# Safety Evaluation Report

NUREG-0101

## Phipps Bend Nuclear Plant Units 1 & 2

Tennessee Valley Authority

FIGURE 6.2-2 CONTAINMENT PRESSURE ANALYSIS - MAIN STEAM LINE BREAK

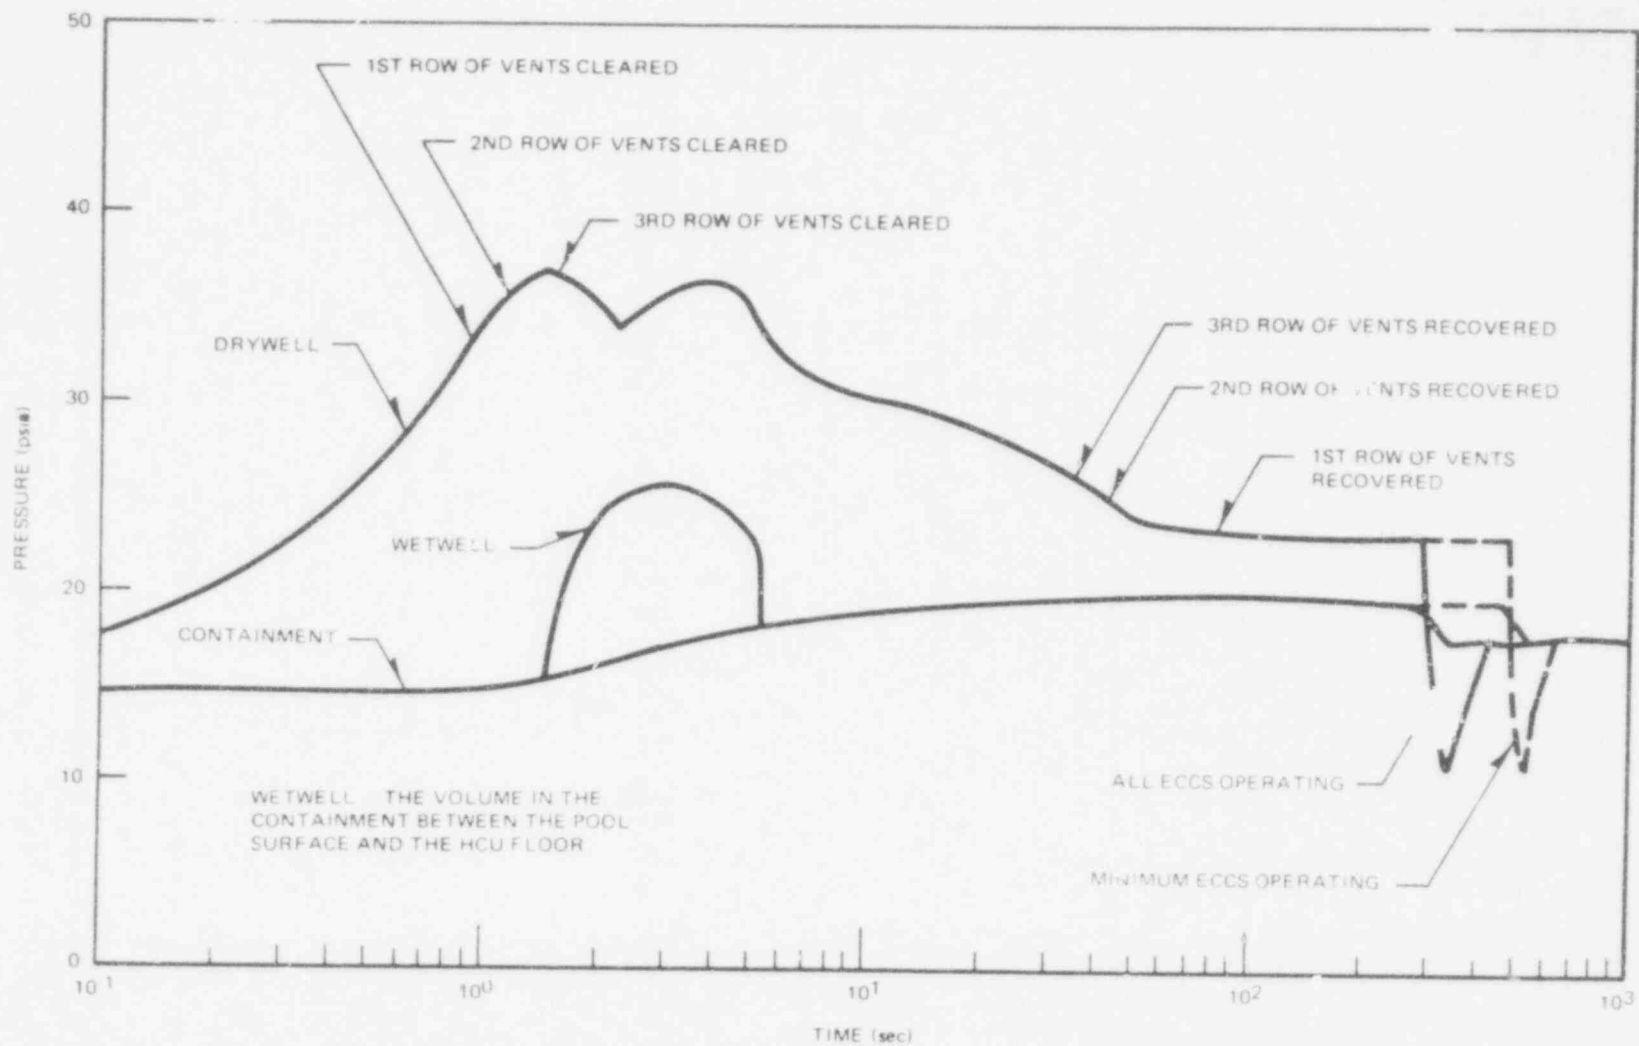
In the GESSAR containment analysis GE has assumed a level rise time of one second and based on this assumption has calculated that the peak drywell differential pressure would be 21.8 psid (Figure 6.2.2). GE has also provided studies of level rise time as a function of operating conditions which indicate that the most rapid level rise would be about one second assuming a hot standby condition.

As shown in Figure 6.2.2 the short term containment response is calculated for two regions; the wetwell, which includes the volume between the suppression pool and the Hydraulic Control Unit (HCU) floor, and the remainder of the containment volume. As indicated on Figure 6.2.2, the two volume analysis does not show any significant effect on peak calculated drywell differential pressure. GE has recently made available the details of their analytical approach. The staff is presently reviewing this information and will report on this aspect of the analysis in a supplement to the SER post-PDA. In the interim, GE has committed to increasing the available flow area at the HCU floor, if required, to maintain an adequate drywell pressure margin. We consider this commitment satisfactory for the PDA.

Figure 6.2-4 Pool Swell Impact Load Time Profiles

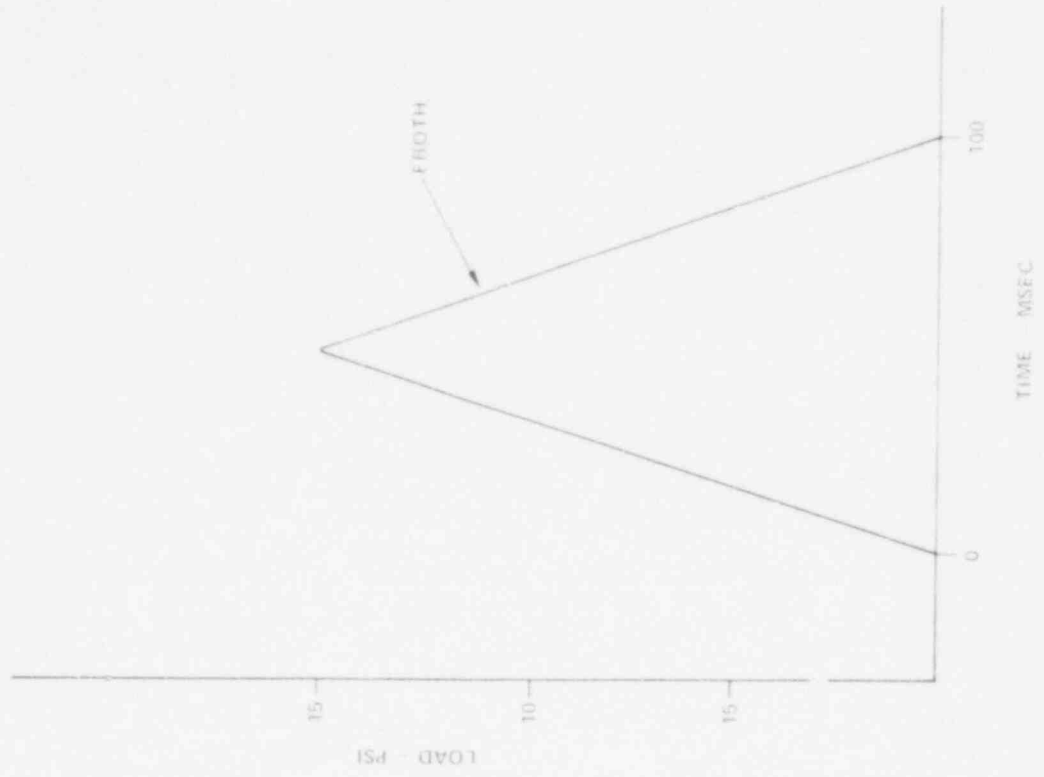
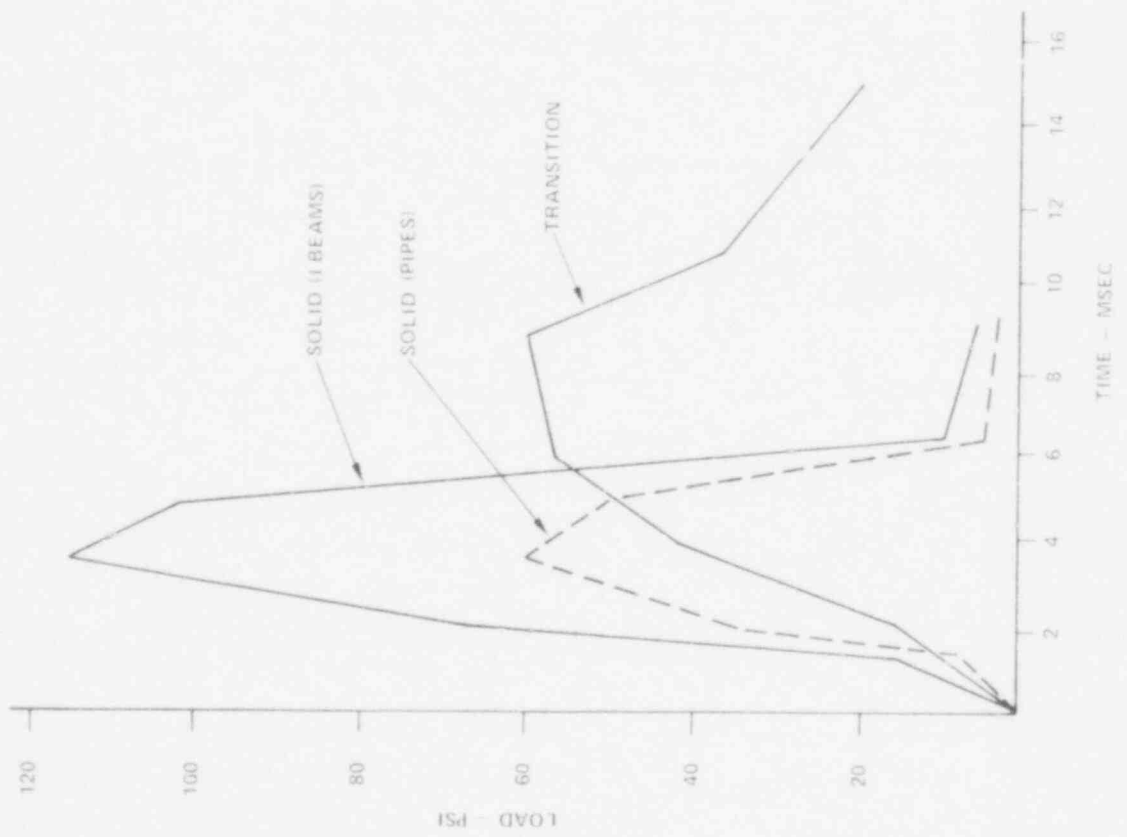
structures (e.g., piping and beams). If the GE profiles cannot be substantiated to the satisfaction of the NRC staff, GE will design these structures in accordance with options (a) or (b) cited above.

FIGURE 7-1 REACTOR TRIP SYSTEM

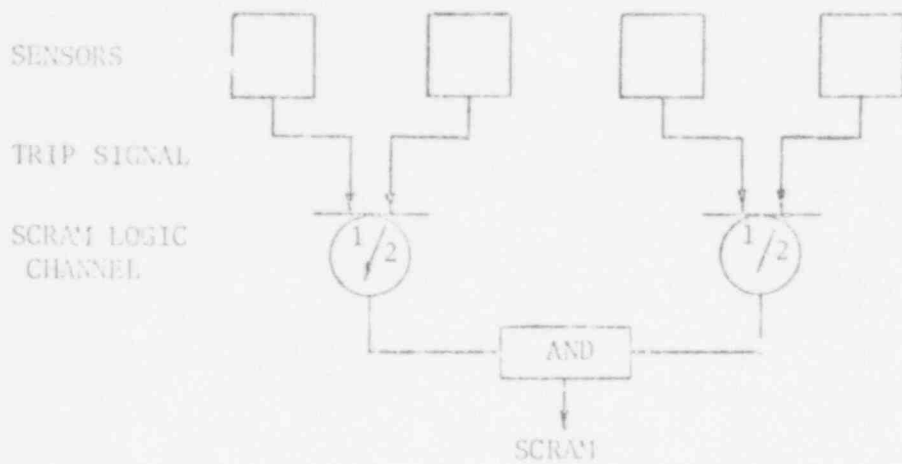
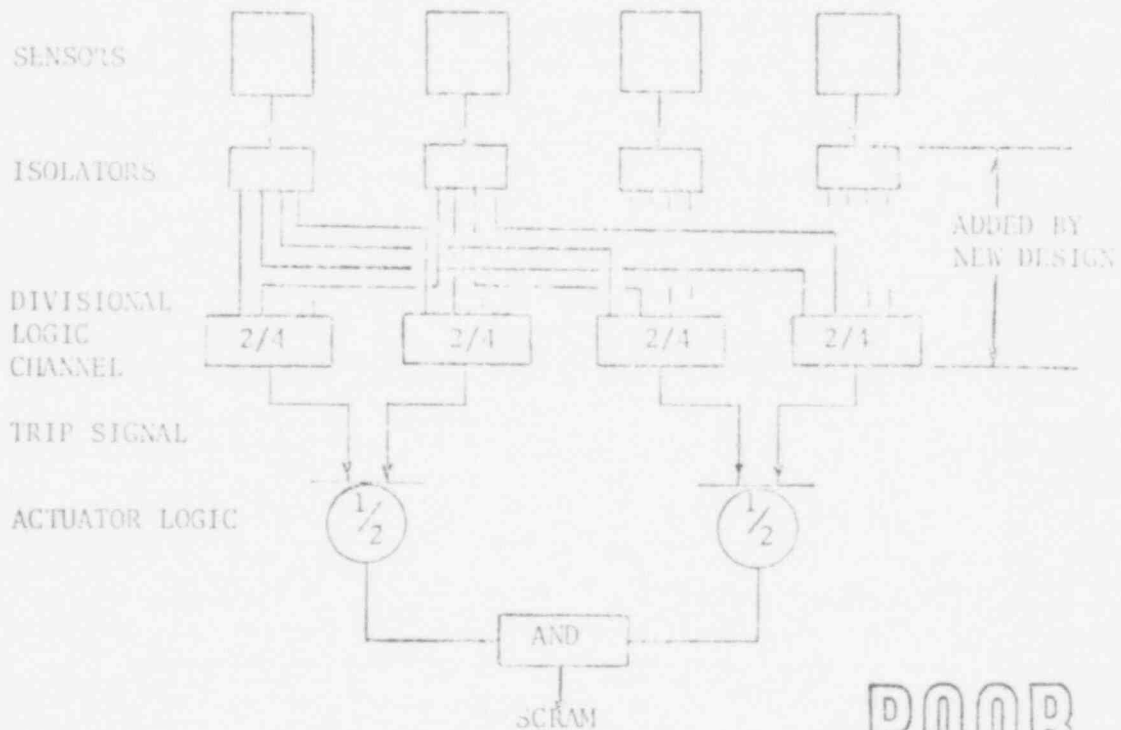
As stated earlier, the proposed conceptual design for the reactor trip system will utilize logic that is different from all previous BWR plant designs as shown in Figure 7-1 of this SER. There will be four identical divisional logic channels and each of these four channels will receive input signals from four sensors per monitored system variable. Each of the four sensors associated with each monitored variable provides an input signal to each of the four divisional logic channels through isolation devices. The divisional logic channels utilize "2-out-of-4" logic for each set of four input signals to generate a trip signal, i.e., when 2-out-of-4 signals for a given input variable exceed the trip set point, a divisional logic trip output signal is produced. The divisional logic output signals are the input signals for the actuator logics which control the electric power for the scram pilot solenoid valves. The actuator logics utilize "1-out-of-2 taken twice" logic to initiate a reactor trip by deenergizing the scram pilot solenoid valves. The conceptual design arrangement described above is illustrated in Figures 7.2-3a through 7.2-3f of GESSAR. The manual scram logic and back-up scram valve logic will be "1-out-of-2 taken twice" as in present BWR designs. The functional arrangement of the solenoid-operated pilot scram valves, the solenoid-operated back-up scram valves, and the air-operated scram valves will also remain the same as in current BWR plant designs.

In Amendment No. 24 to GESSAR, the conceptual design of the reactor trip system was again changed but we have not completed our review of these recent design changes. The most significant changes appear to be that the reactor trip system busses and power supplies were reclassified as non-Class IE and a feature was added to trip open the power supply breakers on a LOCA signal. We do not understand the purpose of this feature, the source of the LOCA signal, or the method of implementing this feature since it appears that opening the breakers will also result in deenergizing portions of the neutron monitoring system, the nuclear boiler instrumentation system and the process radiation monitoring system. Amendment No. 24 did not include any discussion of the design change for our evaluation.

Since a preliminary design of the reactor trip system has not been submitted, our review efforts have been directed principally toward understanding the proposed conceptual design and insuring that the proposed design criteria satisfy the Commission's regulations. With respect to the criteria listed or referenced in Figure 7.1-2 of GESSAR and identified by GE as applicable to the reactor trip system, we have concluded that the designs will be based on the application of current technology and the criteria form a generally acceptable basis for proceeding with development of a preliminary design and are acceptable for the PDA subject to the staff review and approval of a preliminary design. This aspect of the review will be conducted as a post-PDA item and the results will be reported in a supplement to the GESSAR Safety Evaluation Report.

Figure 4 MEASURED VS. PREDICTED CRITICAL HEAT FLUX FOR ATLAS DATA WITH UNIFORM AXIAL AND UNIFORM RADIAL POWER PROFILES

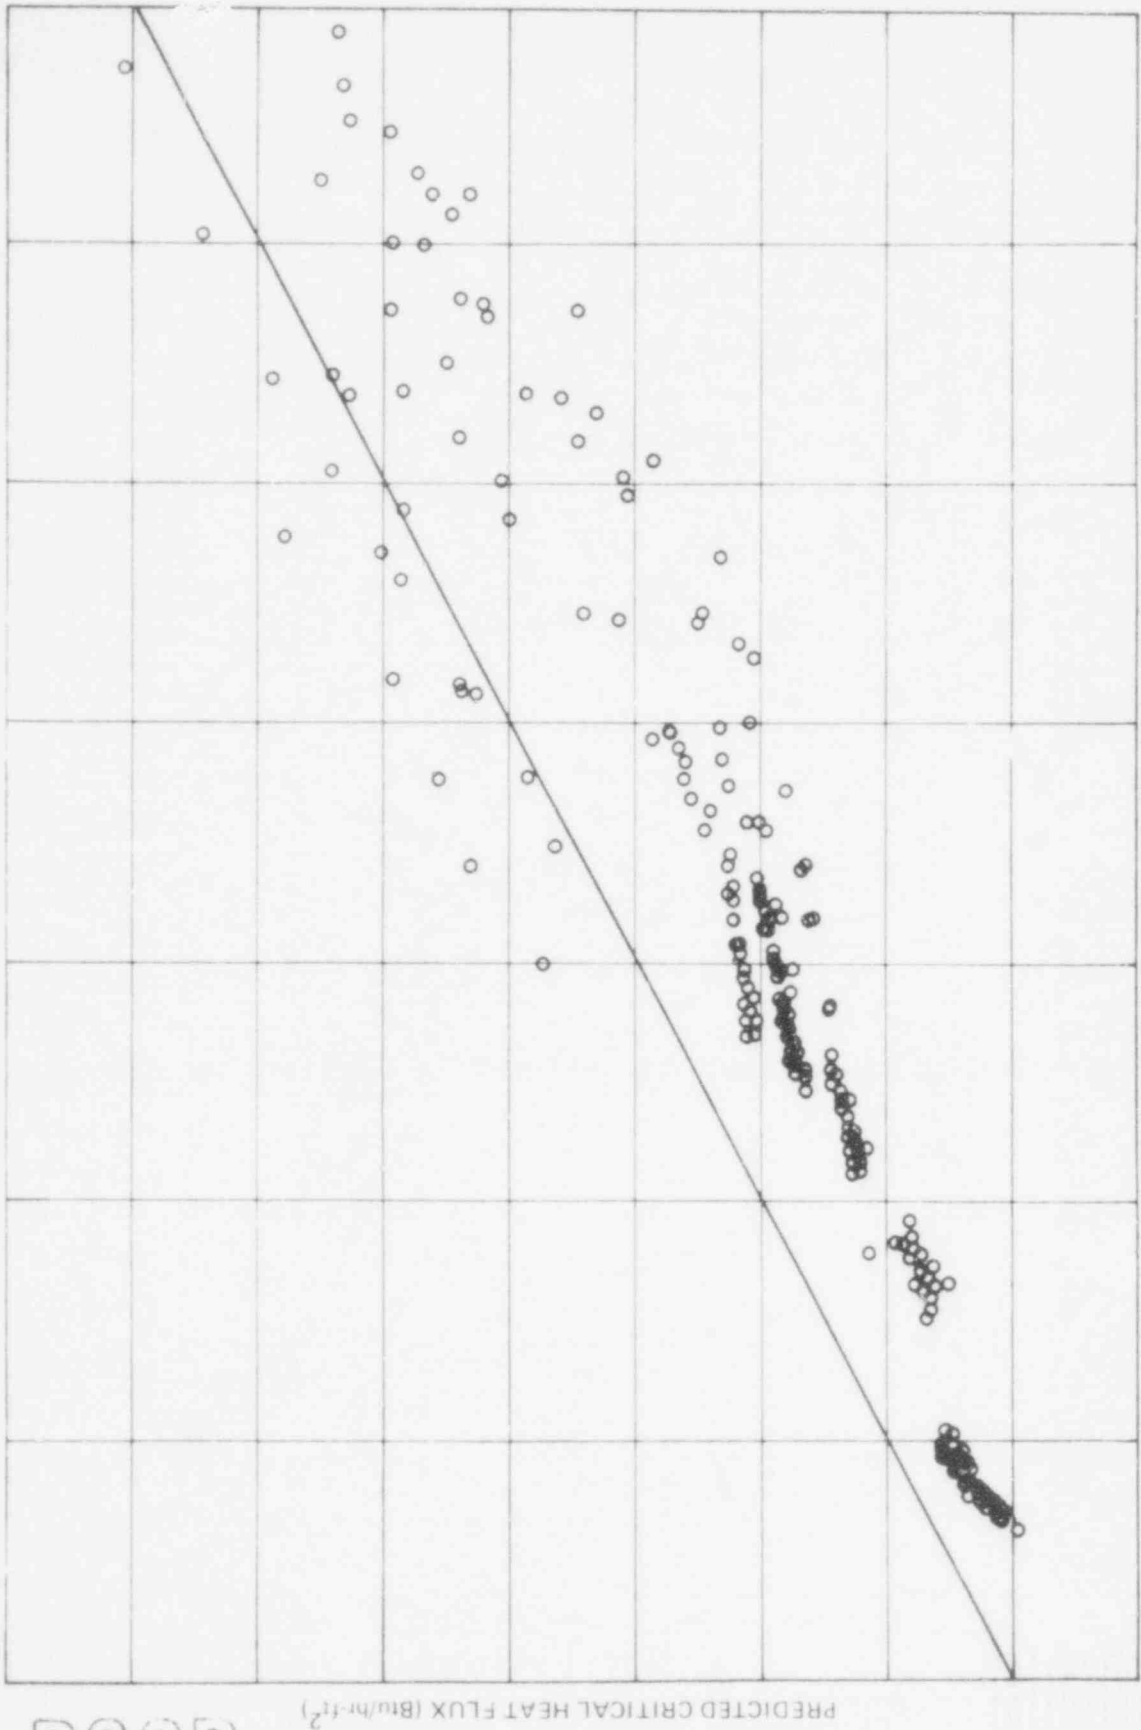
A comparison between measured and predicted critical heat flux (Hench-Levy) for uniform axial and radial heat flux distribution, is shown in Figure 4.<sup>(17)</sup> It can be seen that almost all of the measured heat fluxes are greater than the predictions thus showing that, for these conditions, the Hench-Levy correlation is conservative. This result is not too surprising as the experimental basis for establishing the Hench-Levy correlation was primarily comprised of uniform axial and radial heat flux rod bundle data. However, as shown in the following two figures, the greater the departure from uniform axial and radial heat flux distribution, the greater becomes the disparity between the Hench-Levy correlation and measured critical heat fluxes, with Hench-Levy being the higher.

Figure 5 MEASURED VS. PREDICTED CRITICAL HEAT FLUX FOR ATLAS DATA WITH UNIFORM AXIAL POWER PROFILE

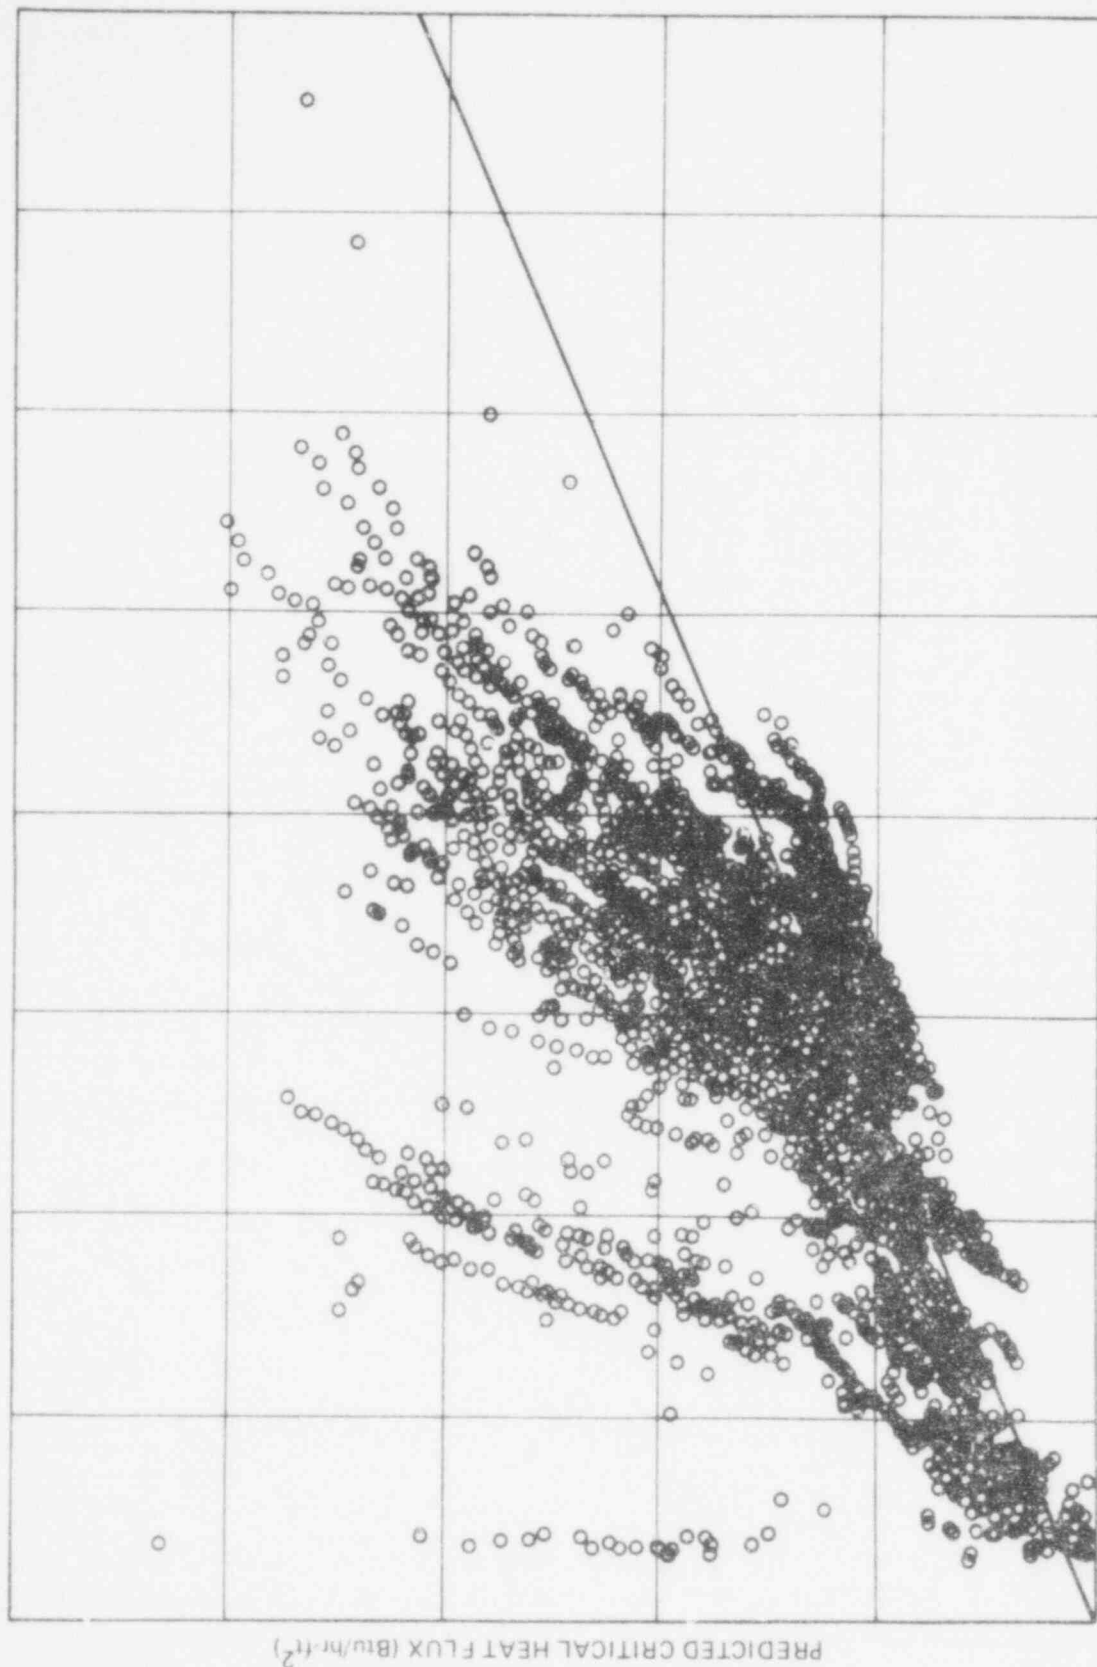
Figure 5,<sup>(17)</sup> which compares critical heat flux for uniform axial heat flux and non-uniform radial peaking to predictions, shows that about one-half of the data points are less than the Hench-Levy prediction. When corner peaking is combined with non-uniform axial heat flux distributions (cosine, inlet peak, outlet peak double hump), the comparison in Figure 6<sup>(17)</sup> results. Here it is seen that, for the vast majority of data points, the Hench-Levy predictions substantially exceed the measured critical heat fluxes. Thus, it can be concluded that, for rod bundle heat flux distributions and heat lengths which correspond to those found in a GE BWR (non-uniform axial heat flux with corner peaking, 12 ft. heated length) the Hench-Levy correlation does not provide a lower limit line.
